TOWN OF ARLINGTON
Purchasing Department
730 Massachusetts Avenue
Arlington, MA 02476
Telephone 781.316.3003

Invitation for Bids #26-03
Roof Replacement - Parmenter Building

ADDENDUM NO. 1

Town of Arlington
26-03 Roof Replacement – Parmenter Building
Safety Site Plan

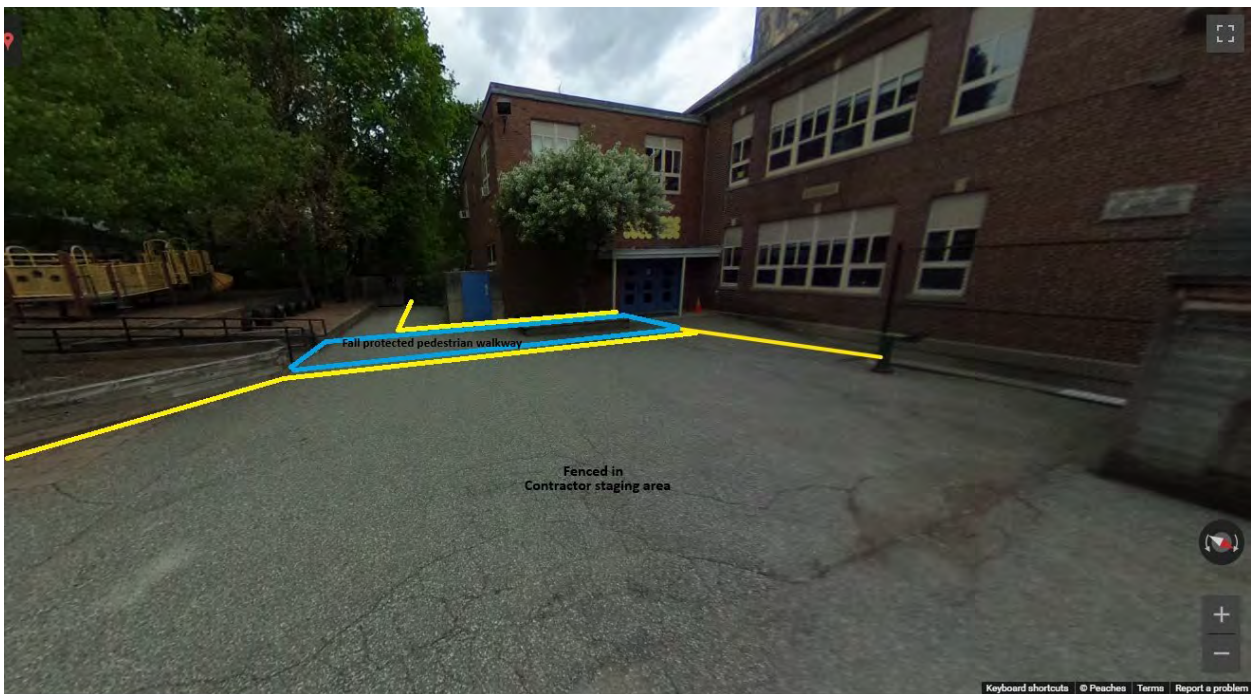
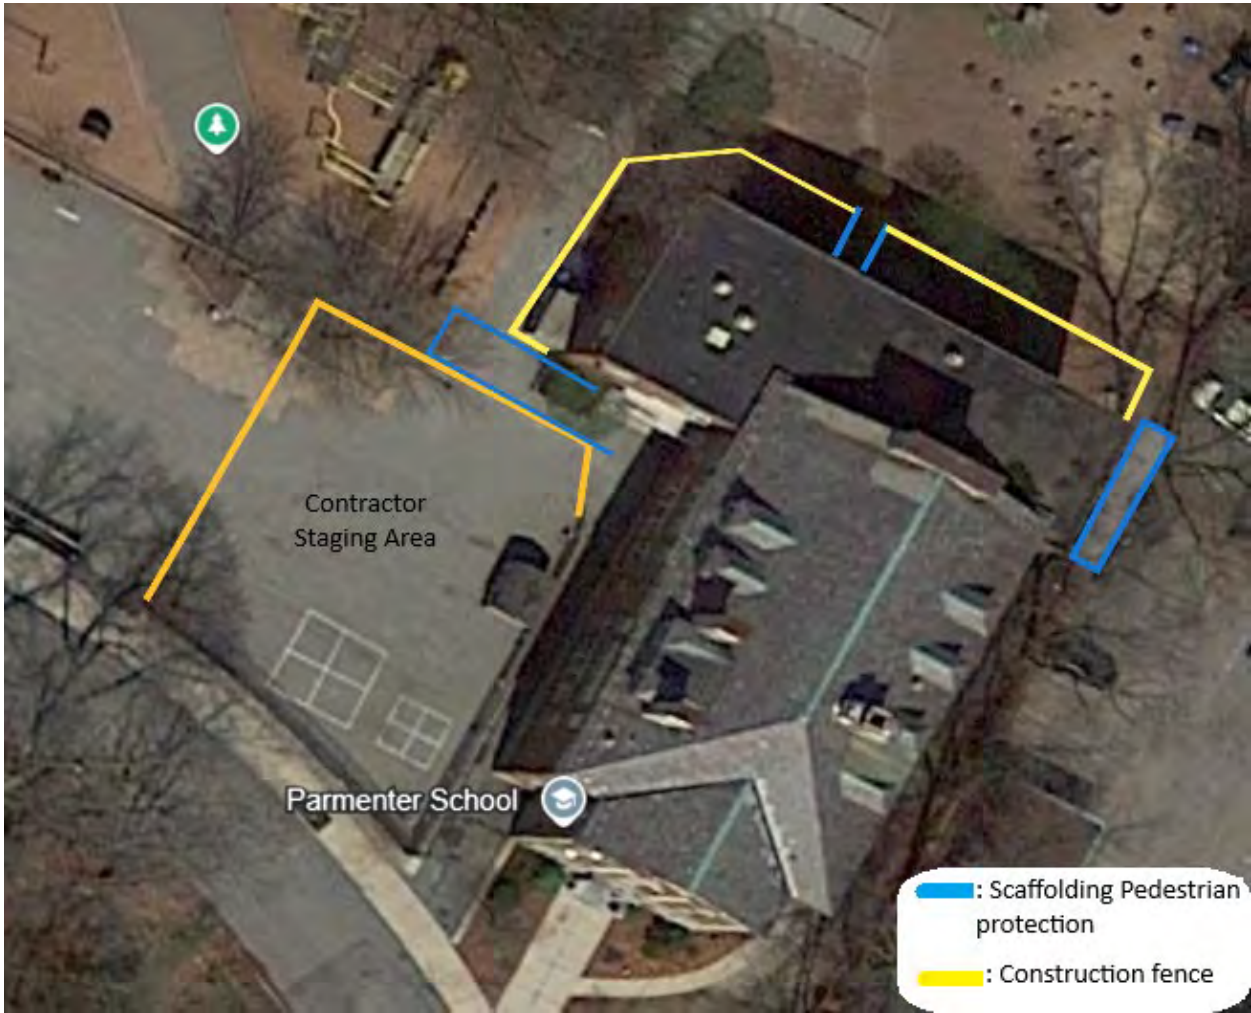
6. **Question:** Where is the best location to set up operation?
Answer: The best recommended location to set up operation is the parking lot adjacent to the building, which will require coordination with Town as the building will remain in use, primarily as a daycare, during construction.

- Please see proposed site safety plan provided herewith as **Attachment D**. The Contractor shall provide approximately 250 linear feet of safety construction fencing around the perimeter of the flat roof and 70 linear feet of scaffolding overhead protection for pedestrian walkways at three locations.*
